DEPARTMENT OF ECOLOGY

Re: Further Action at the following Site:

• Site Name: Glacier Recycle

• Cleanup Site ID No.: 12326

Figure 2 Locations of Soil Sampling and Ground Water Monitoring Well at the Site

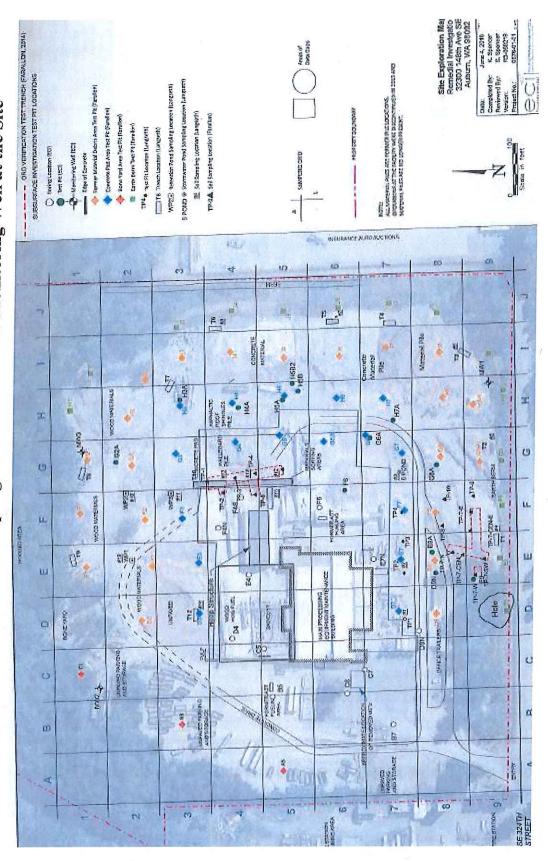
- The horizontal and vertical boundaries of COCs exceeding the cleanup levels in soil need to be further delineated prior to developing a cleanup action plan (CAP).

- All the three existing ground water monitoring wells were installed around the
 Property boundary. Ecology recommends addition of at least three monitoring
 wells at locations within the Property boundaries, to identify contamination status
 in the ground water immediately downgradient of identified soil contamination
 (see Enclosure A, Figure 4). The data can also provide more information to
 develop an accurate ground water contour map and assess the ground water flow
 directions.
